Our Case Number: ABP-314610-22

**Re:** BusConnects Ballymun/Finglas to City Centre Core Bus Corridor Scheme  
Ballymun/Finglas to Dublin City Centre

Written Submission from Dublin City  
Council Chief Executive

BusConnects Dublin – Ballymun/Finglas to City Centre Core Bus Corridor Scheme  
An Bord Pleanála Ref. HA29.314610

Figure 9

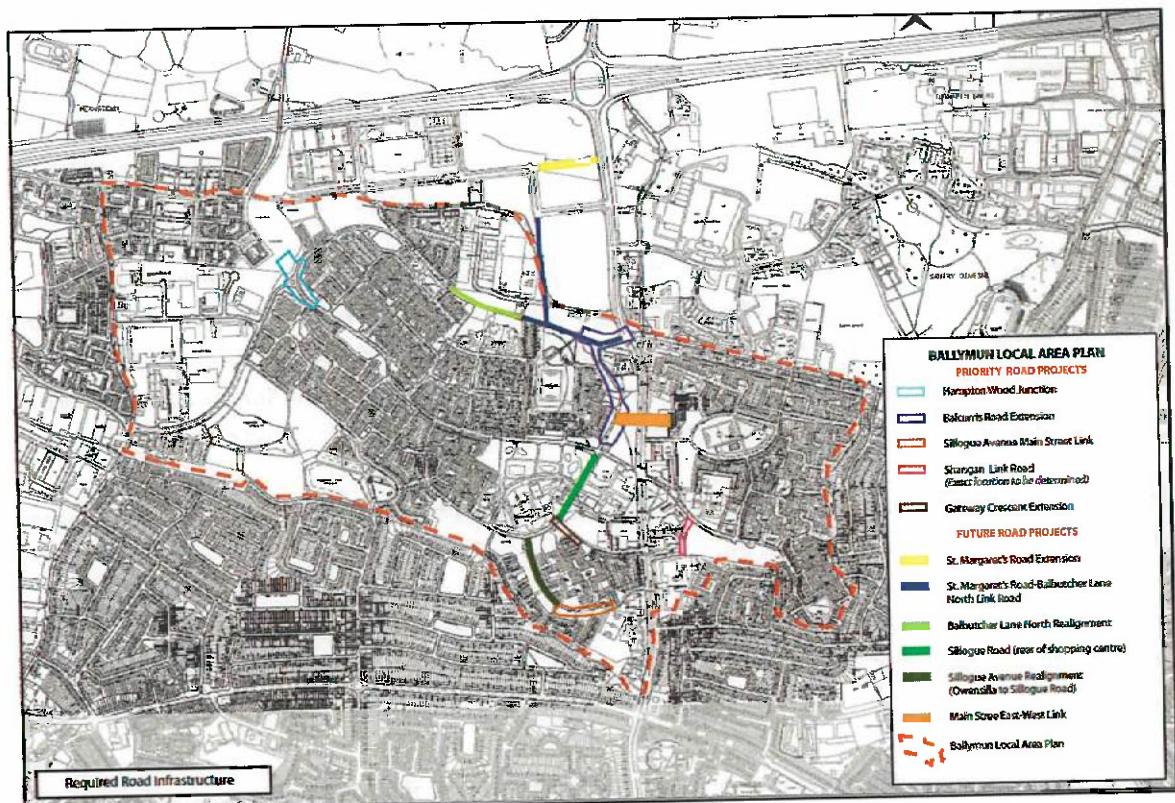
Concerning Objective M01, and the outstanding road infrastructure projects set out in the LAP, attention is drawn in particular to the proposed new East-West link identified as a future road project, see Fig 9 of the LAP below. The LAP seeks a new-west link connecting the neighbourhoods of Balcurris and Coutry, provided within Site 6 of the LAP to the east of Main Street and between sites 4 and 5 to the west. Attention is drawn to this objective concerning the proposed location of the bus stops in this vicinity. The NTA should ensure that the proposal put forward does not jeopardise the deliverability of the LAP objective.

Concerning car parking provision along Main Street and Objective M08 above, it is acknowledged that the provision of a multi-storey car park is clearly outside the remit of this project, however, there is a need to ensure that there is some level of parking to serve the commercial Main Street, to support the economic viability of existing and future commercial, recreational and cultural uses, and aspirations to create Ballymun as a destination point, in keeping with its District Centre status under the City Development Plan. In this regard, the proposed removal of on-street parking on either side of Main Street, to the south of Santry Cross and the lack of alternative provision in this location is considered detrimental to the existing and future commercial uses south of Main Street.

Conversely, the proposed provision of significant new car parking between the Plaza, Cearnóg an tSeachtar Laoch and the old Shopping Centre site (Site 1 of the LAP) is considered at odds with the urban design objectives for this location. It is a key objective of the LAP to support pedestrian connectivity and to link the plaza and Site 1, both visually and physically at this location. This is even more important in the context of the proposed Metrolink station at this location. The applicant should have regard to the Part 8 Planning consent granted for the Plaza in September 2021 (Reg. Ref. 3131/21), the on-site works of which are expected to commence in 2023. The overprovision of car parking at this particular location, as proposed, would seriously detract from the creation of a pedestrian-focused civic space. The design brief for Site 1 within the LAP states:
